Our Ref: 11224019-03  
TBG Ref: 20697

18 January 2022

Re: Response to Comments – 787 & 825 Fallis Line, Millbrook ON  
County File 15T-21007

GHD Limited (GHD) is pleased to present the following responses to various agency comments received regarding the geotechnical and hydrogeologic investigation reports and environmental site assessment report completed for the above noted properties located on Fallis Line in Millbrook, Ontario. GHD responses follow the respective agency comments.

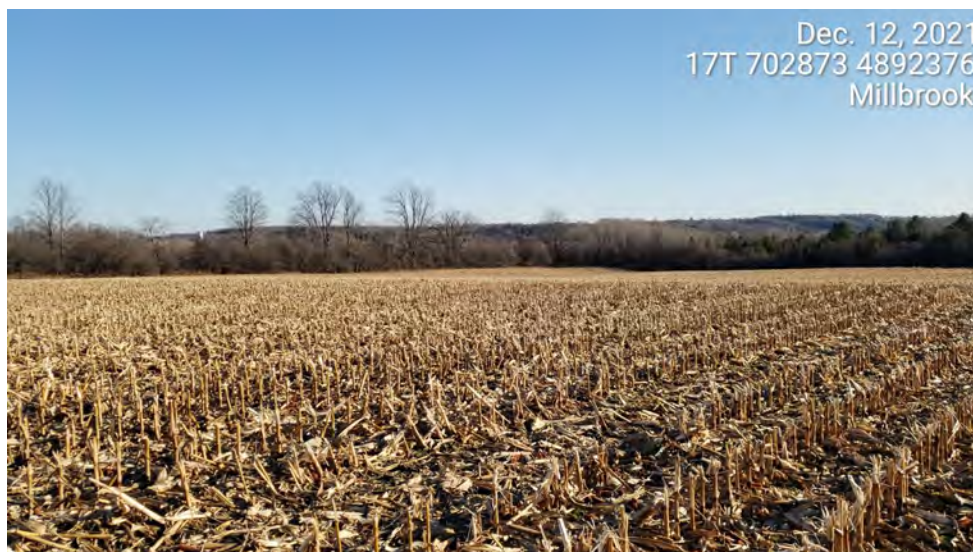
21. *The Site was reported to be snow covered at the time of the site reconnaissance. This is not an allowable limitation under O.Reg. 153/04. It is unclear how GHD concluded that there were no signs of deleterious fill materials at the Site. Furthermore, stained surficial materials or stressed vegetation, if present, would not be observable under snow covered conditions. GHD should conduct a site*

*reconnaissance when snow cover is not present to confirm that there are no obvious deleterious fill materials, stained surficial materials, or stressed vegetation at the Site.*

22. *Although Stantec generally agrees that the historical rail line PCA is not likely to contribute to an APEC at the Site, GHD should further assess and provide rationale on the likelihood that the subsurface beneath the former rail line does not contain fill of unknown quality.*

GHD has conducted various inspections and work programs on the lands on multiple occasions. The undersigned has walked the property as recently as July 2021 and December 2021 without snow cover. It remains our opinion that no signs of deleterious fill, stained surficial materials or stressed vegetation were observed. Photographs are provided in Attachment B illustrating the property conditions on these dates.

A follow up site reconnaissance was completed of the historical rail line corridor to confirm the absence of fill, rail line ties or ballast material. It is our understanding that the rail line was abandoned in 1920. On either side of the former rail line is forested. No discoloured soils or stressed vegetation was observed.

The portion of the rail line within the area to be residentially developed was historically excavated (likely to maintain a gradual grade from top to bottom of the slope) and is lower than the surrounding areas. No rail ties or rail ballast material was observed within the rail line right-of-way.

Where the rail bed was built up is within a heavily forested in this area. A number of areas of the rail bed area have been washed out and eroded over the years. The material observed was generally a brown silty sandy with gravel material. No deleterious fill, ballast or discoloured material was observed. Based upon our observations, the likelihood of significant impacts below the former rail line appears low.
